ARCHITECT'S SUPPLEMENTAL INSTRUCTIONS

PROJECT:	Roosevelt Lofts Historic Rehabilitation San Angelo, TX	Report No.	Five (5)
OWNER:	Overland Property Group 234 N. Santa Fe Ave, Suite A Salina, KS 67401	Date	June 5, 2024
CONTRACTOR:	MCP Group 3501 SW Fairlawn Rd. Topeka, KS 66614	Architect's Proj No.	22-3281
		Contract For:	General Construction Mechanical, Electrical

DESCRIPTION:

A2.3

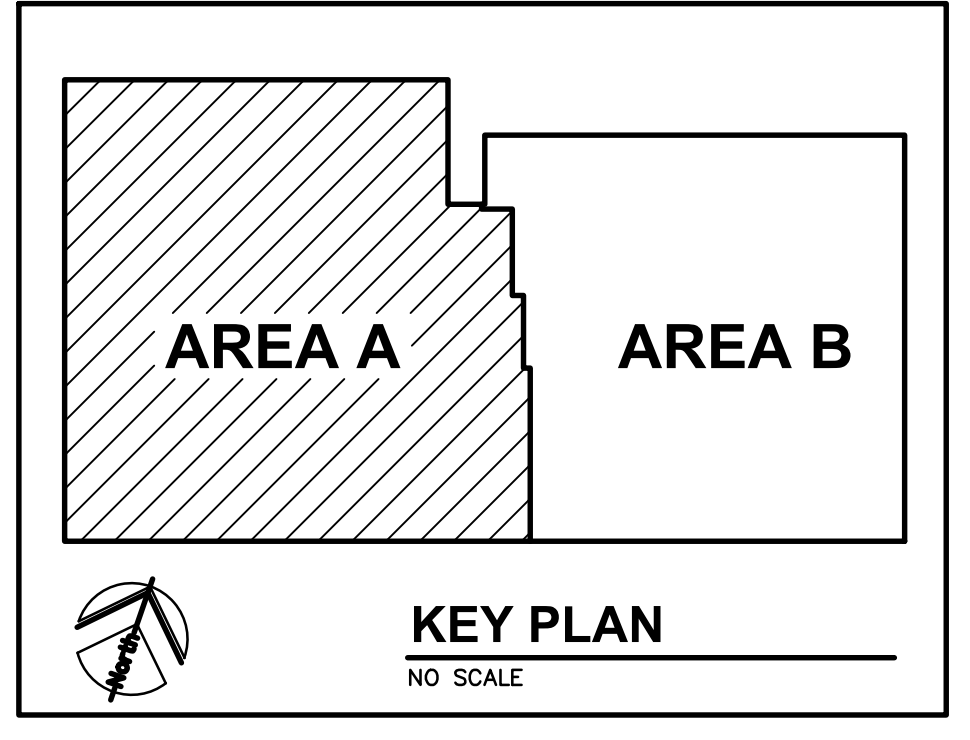
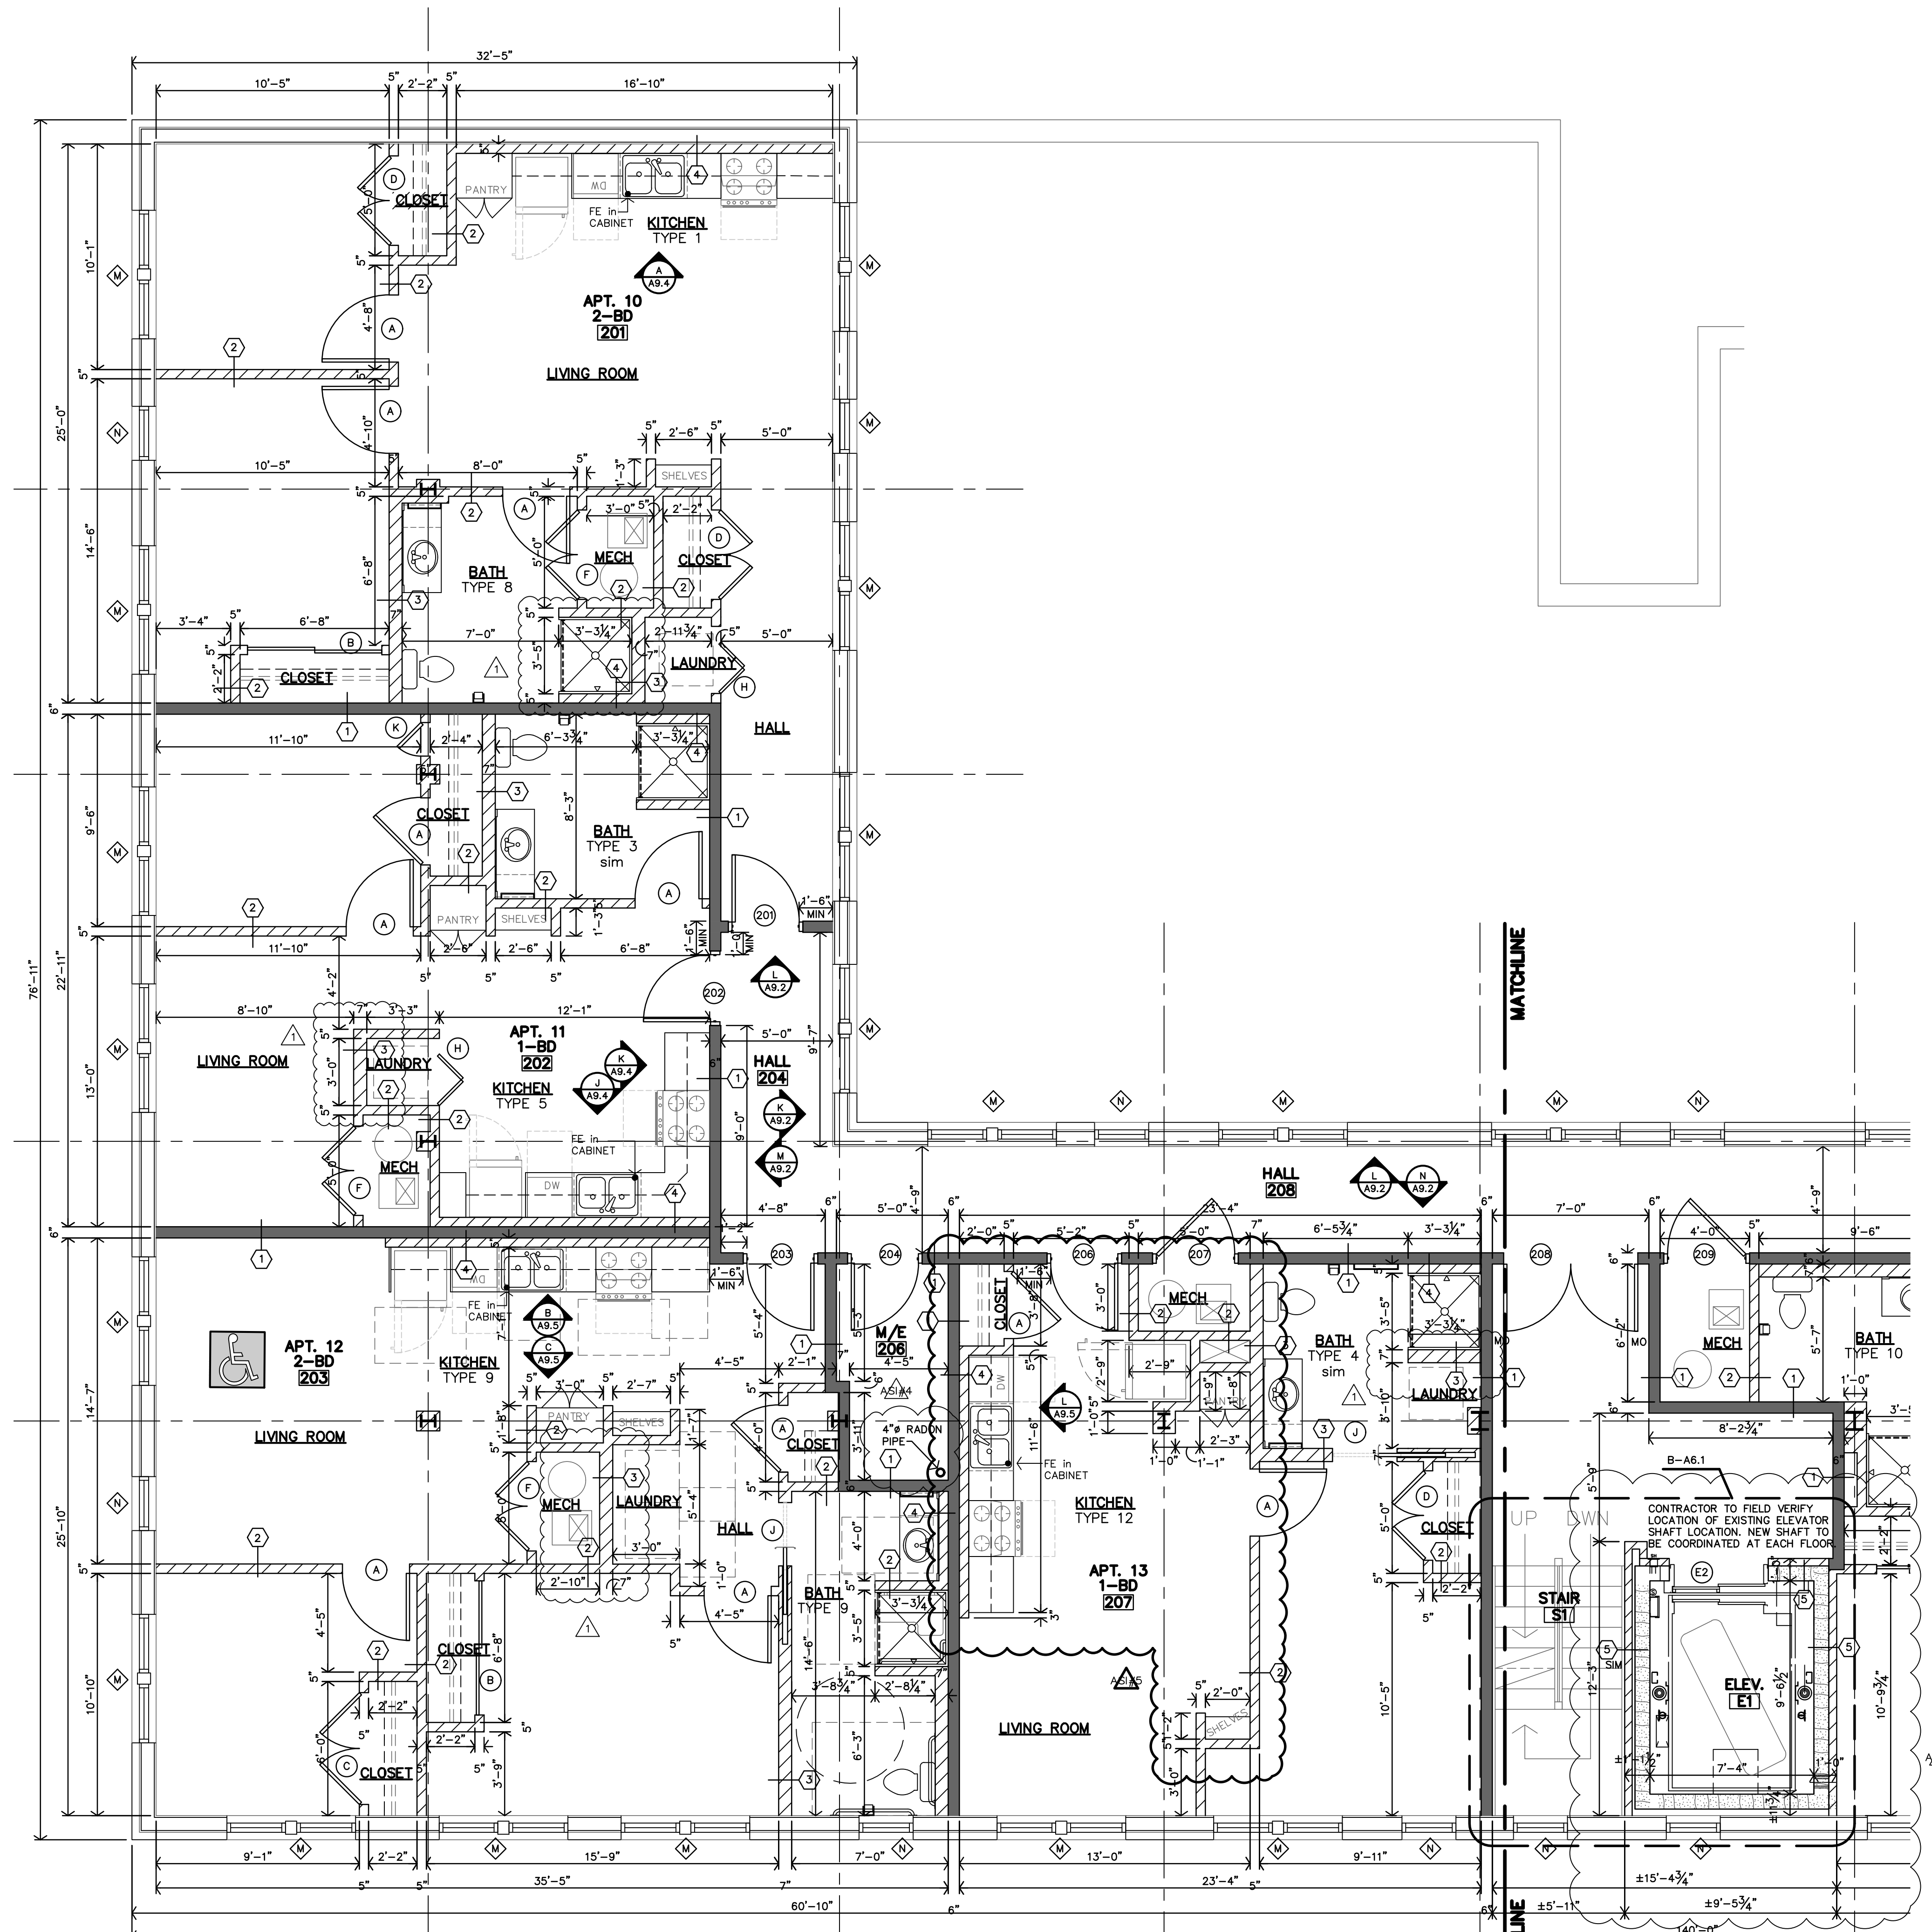
1. Apartment 1 (Rm #109) – Kitchen casework, fixtures and appliances have been rearranged to avoid a conflict between the entry door clearances and the refrigerator. Reference revised sheets A2.3, A-A9.5, M1.8, E1.1

4. Door 121 (into Apt. 5, Rm #118) – shift door & frame 24" to the east, and swing changes to Right-Hand. Revised plan on Sheet A2.3
5. Kitchen Party Wall between Apt. 14 (Rm #209) & Apt. 15 (Rm #211) – shift 6" to the east. Revised plan on Sheet A2.6

AREA A SECOND FLOOR PLAN
1/4"=1'-0"

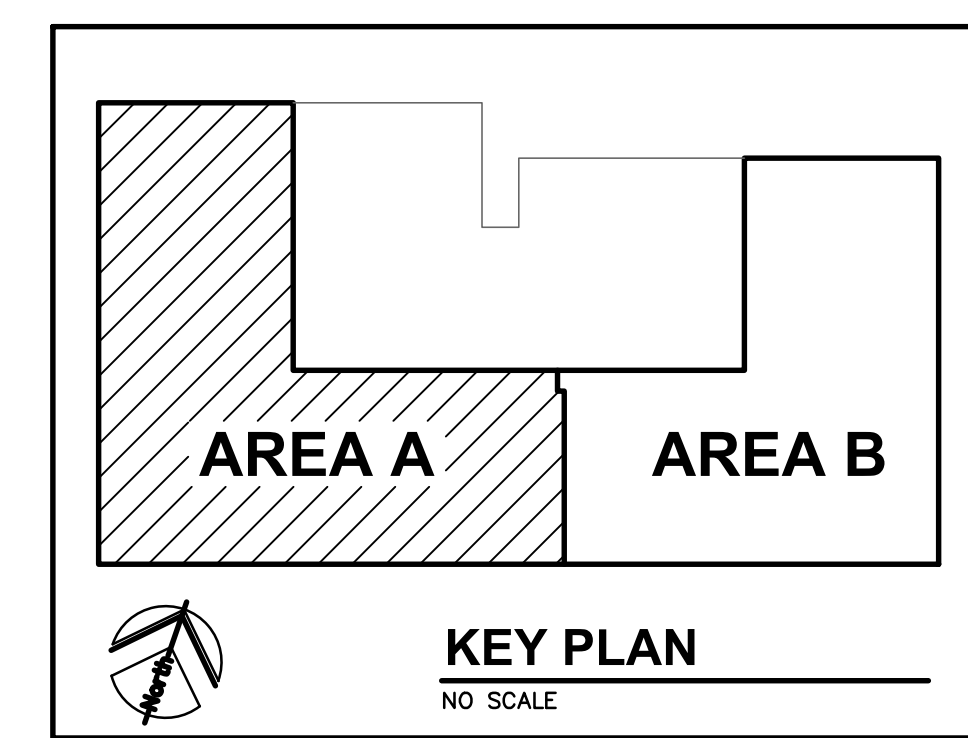
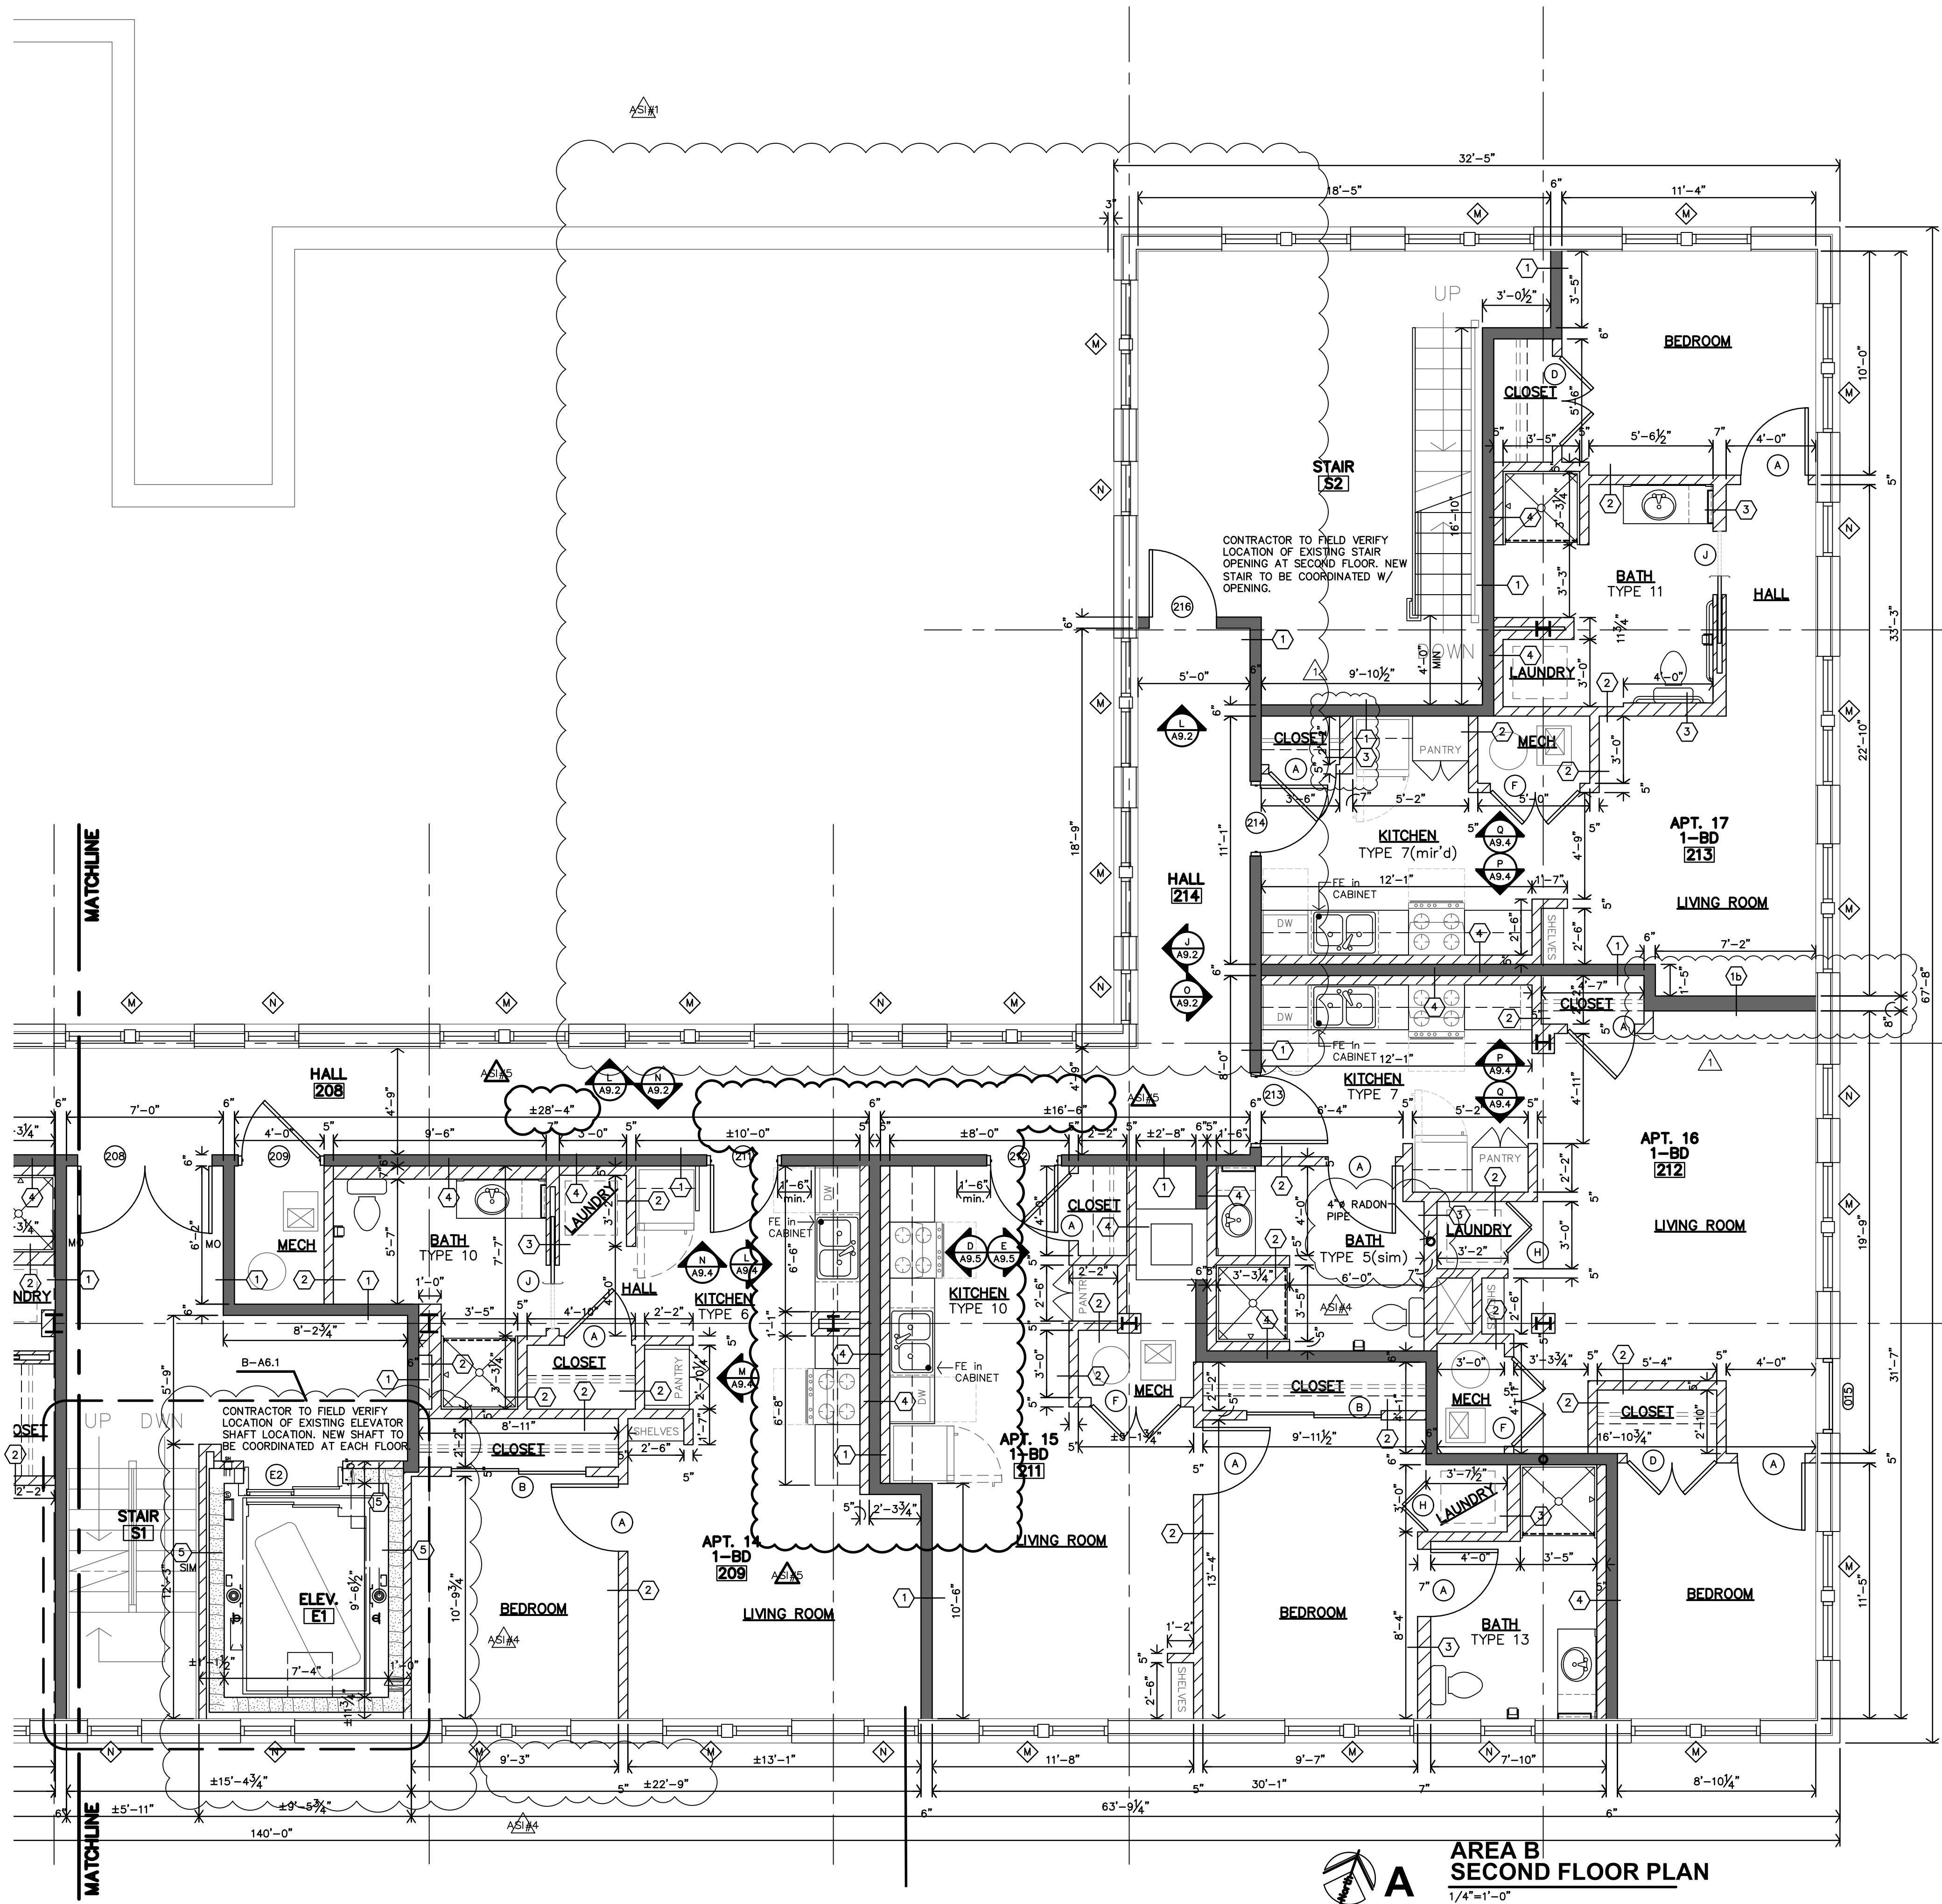
2. Apartment 13 (Rm #207) – Kitchen casework, fixtures, appliances, closet & shelves have been arranged to avoid a conflict between the entry door clearances and the refrigerator. Reference revised sheets A2.5, A9.5, A7.2, M1.9, E1.3, E1.10
